**PLANNING AMENDMENTS**

Client  
**RFU**  
 Project  
**TWICKENHAM STADIUM EAST STAND EXTENSION**  
 Drawing title  
**GA SECTION B**

Doc ref	Project number	Drawing number	Revision
100-KSS-DR	15735	202	P03

**1 SECTION**  
 B SECTION GA  
 1 : 200

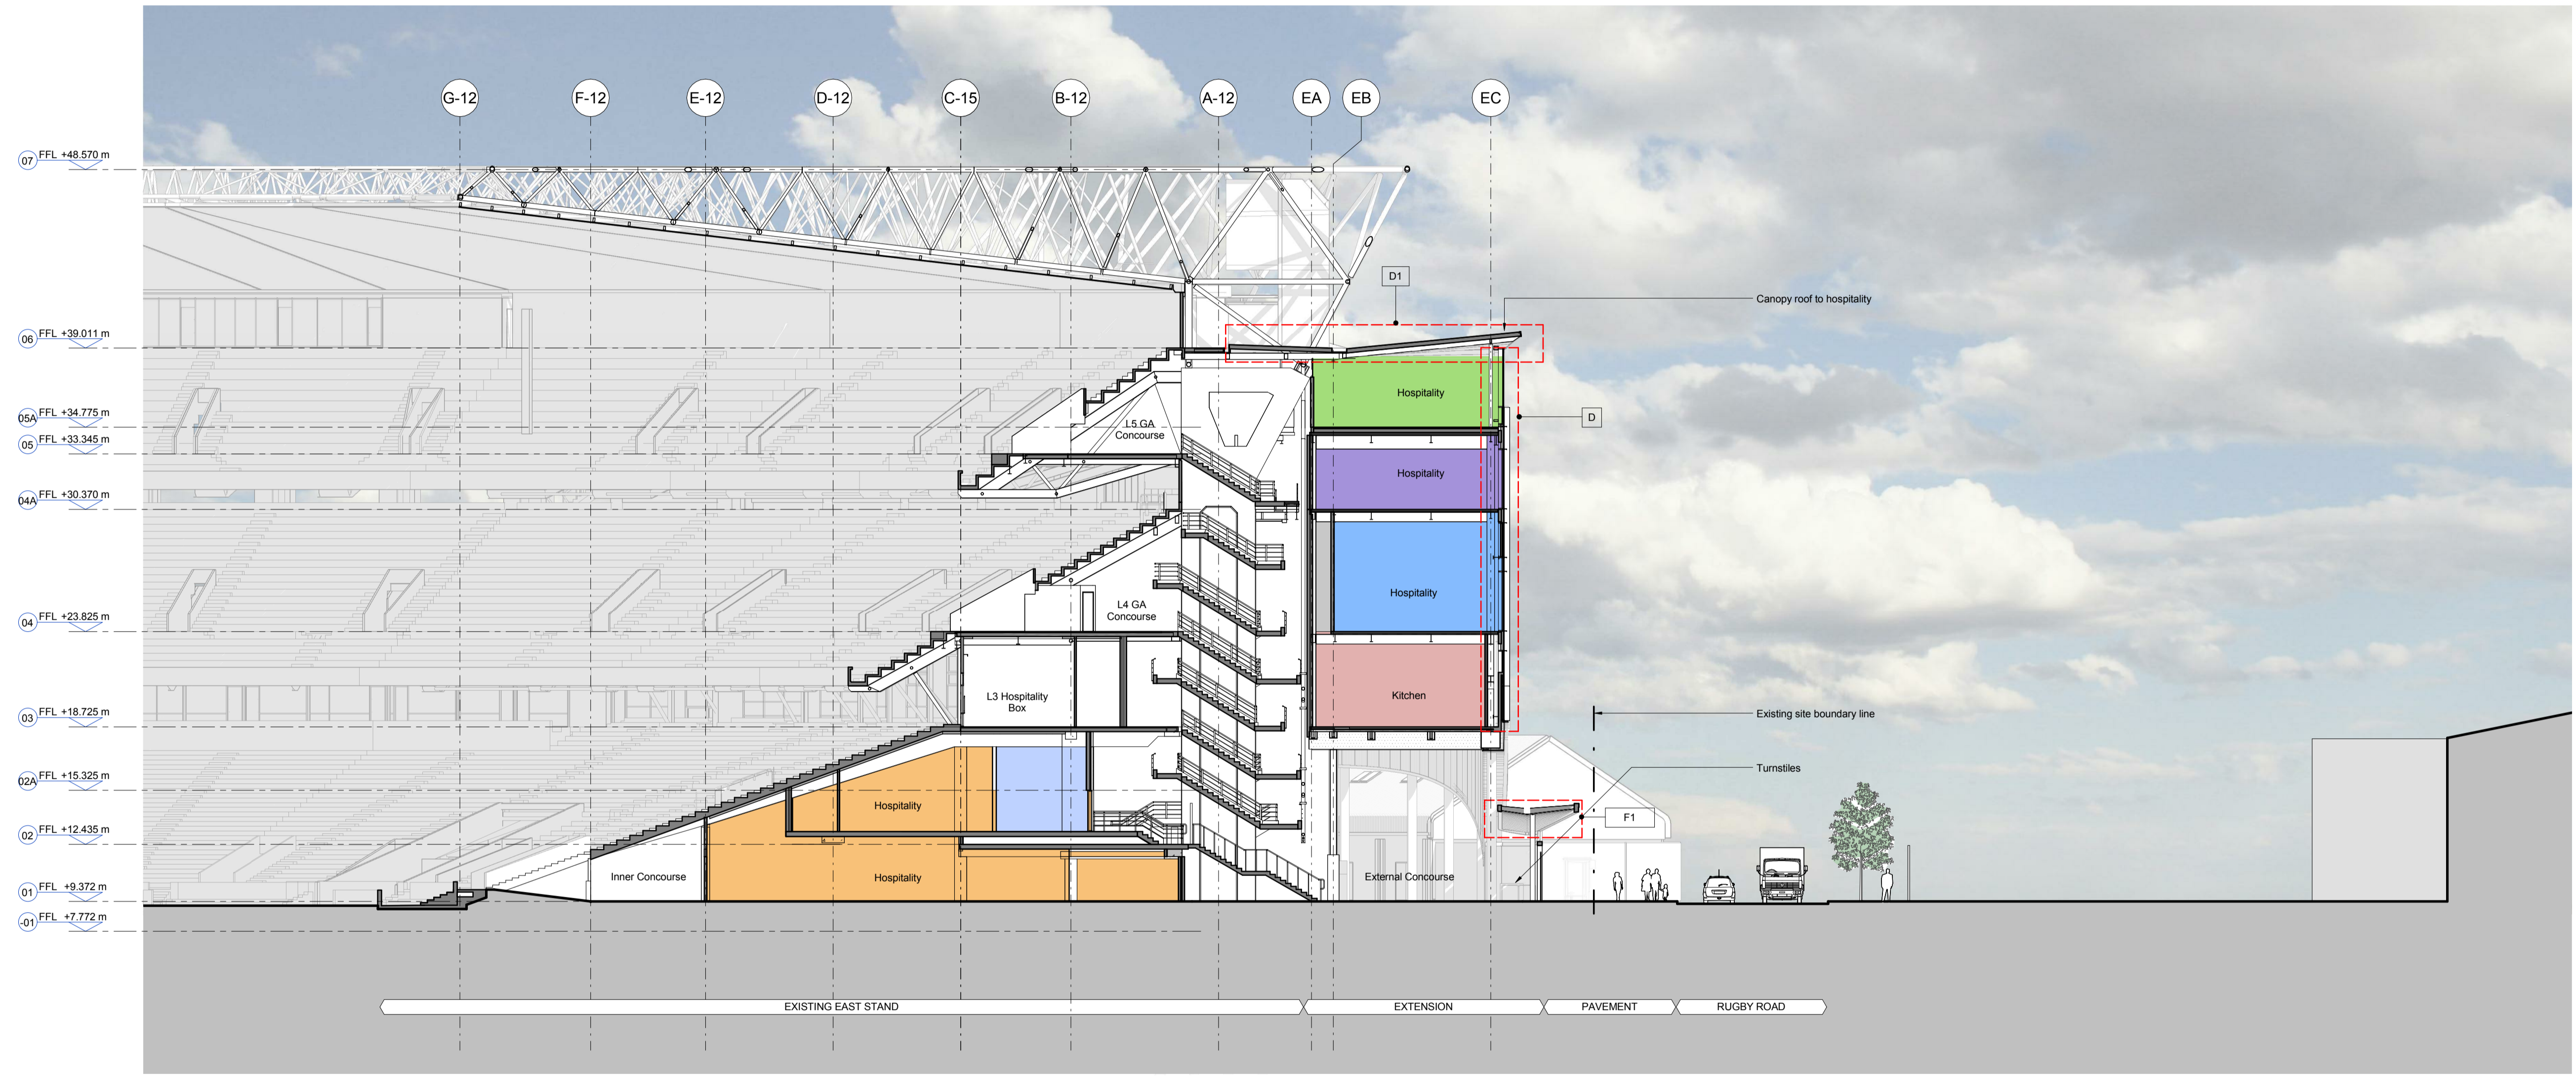
- A GENERAL AMENDMENTS TO THE SOUTH END.
- A1 INCREASED SHINGLES CLADDING AREA AND CURTAIN WALL REDUCED ACCORDINGLY.
- A2 REDUCED MASSING AND REVISED INTERFACE WITH THE SOUTH STAND.

- B PPC LOUVRES LOCATED TO THE BOWL SIDE HAVE BEEN OMITTED.
- C CURTAIN WALL SETTING OUT REVISED GENERALLY. SILICONE JOINTS TO TRANSOMS AND MULLION REPLACED WITH CAPPED SYSTEM. LEVEL 04 PPC LOUVRES SETTING OUT & HEIGHT REVISED. MONORAIL FOR ABSEILING REMOVED.

- D GENERAL AMENDMENTS TO THE CENTRAL ELEVATION CANOPY AT LEVEL 5A REVISED GENERALLY AND STANDING SEAM REPLACED WITH SINGLE PLY MEMBRANE. SUPPORT COLUMNS TO ROOF CANOPY REVISED. SQUARE FASCIA TO ROOF EDGE.

- D1 LEVEL 5A GLAZED SCREEN EXTENDED IN HEIGHT AND PPC LOUVRES INCLUDED AT LOW LEVEL.
- D2 INCREASED SHINGLES CLADDING AREA AND CURTAIN WALL AREA REDUCED ACCORDINGLY. FOUR VERTICAL FINNS REMOVED.

- D3 PORCELAIN PANELS WITH SLOTTED HOLES FOR VENTILATION REPLACED WITH PPC LOUVRES. EXPRESSED HORIZONTAL PATTERN TO PORCELAIN PANELS OMITTED.
- E GENERAL AMENDMENTS TO THE NORTH END PORCELAIN CLADDING REPLACED WITH PPC ALUMINIUM CLADDING.

- E2 GREEN WALL TO THE NORTH END EXTENDED AND PPC LOUVRES REMOVED.
- E3 INCREASED SHINGLES CLADDING AREA AND CURTAIN WALL REDUCED ACCORDINGLY.
- F FENCELINE, GATE AND PERIMETER COLUMNS SETTING OUT REVISED.

- F1 CANOPY TO TURNSTILES REVISED.
- G PORCELAIN PATTERN CHANGED FROM HORIZONTAL TO VERTICAL.
- H PORCELAIN PANELS TO THE SOFFIT OF THE ARCH REPLACED WITH PPC ALUMINIUM PANELS. PORCELAIN PANELS SETTING OUT REVISED.

- K ROOF TO LEVEL 5A (NORTH END) EXTENDED.
- L GLAZED SPANDREL PANELS REPLACED WITH METAL SPANDREL PANEL. PORCELAIN PANELS REPLACED WITH PPC ALUMINIUM CLADDING.

- L1 PPC LOUVRES INCLUDED FOR MECHANICAL VENTILATION.
